## NEBRASKA CAPITOL ENVIRONS COMMISSION

## **Item 2: Residential street rehab project near McPhee School**

CITY OF LINCOLN, NE (2020)  
 PAVING REHABILITATION OF THE  
 McPHEE SCHOOL NEIGHBORHOOD  
 PAVING C.I.P. #705270

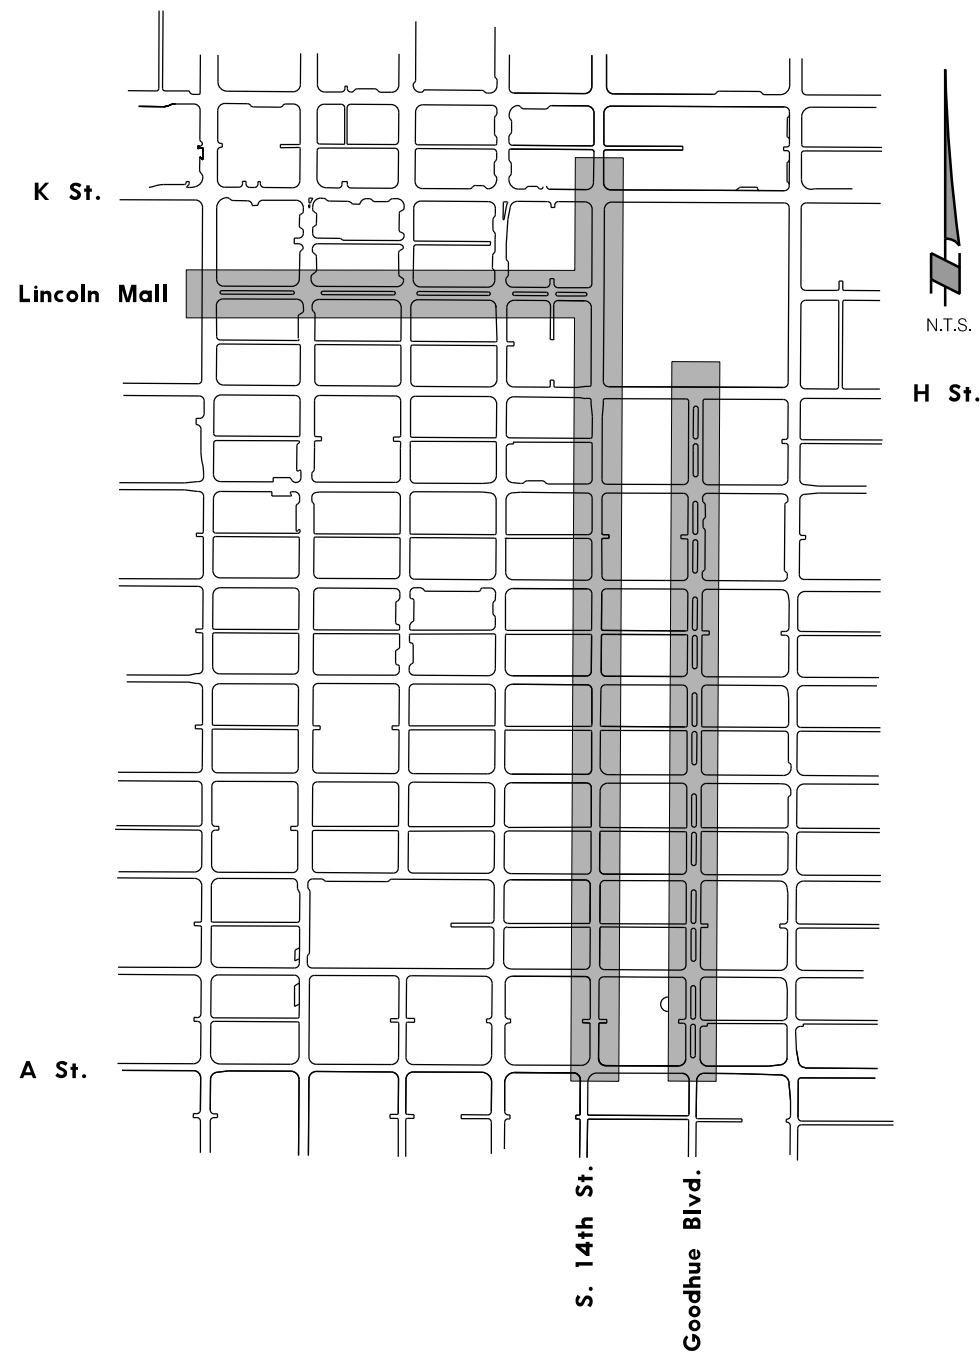
These improvements are intended to enhance the condition and usability of the affected streets and sidewalks. For the most part, they should have little to no impact on the visual quality or character of the Capitol Environs District. One possible exception to this would be the curb ramp improvements along Lincoln Mall. Most of the existing curb ramps on Lincoln Mall were constructed with a colored concrete that differentiates itself from the sidewalk. These same ramps are also surrounded by decorative paver fields that serve as a visual and textural landing zone for pedestrians entering or exiting an intersection. LTU, based on long-term maintenance and liability concerns, is proposing to replace the colored concrete and brick pavers with standard grey concrete in scenarios where curb ramps and sidewalks are being replaced or realigned. Using Lincoln Mall and S 12<sup>th</sup> Street as an example, the two southern corners of this intersection (as shown below) include ADA ramps that will need to be replaced and connecting sidewalks that will need to be realigned to make them fully compliant. As part of this work, it is being proposed that the paver fields be removed and replaced with concrete.

*The photographs above show the southwest and southeast corners of Lincoln Mall and S 12<sup>th</sup> St. As part of the effort to make the curbs ramps ADA compliant, the paver fields at these corners are proposed to be replaced with grey concrete.*

The existing decorative pavement treatments at the corners of the Lincoln Mall intersections play a role in the establishment of the rhythm and organization that Design Standard 18 references. Ideally, improvements at these nodes should not disrupt that rhythm and organization. While the preferred course of action would be to preserve and/or restore the existing paver fields as much as possible, LTU's concerns about their ability to maintain these enhancements long-term are valid. Still, their approach will result in an inconsistent visual aesthetic at the corners of Lincoln Mall's intersections that does not fully align with the expectations of the design standards.

*Recommended Action: Approval of a Certificate of Appropriateness for the residential rehab project, under the condition that the applicant revise the design to establish a consistent approach to the pavement treatments at the corners of Lincoln Mall's intersections.*
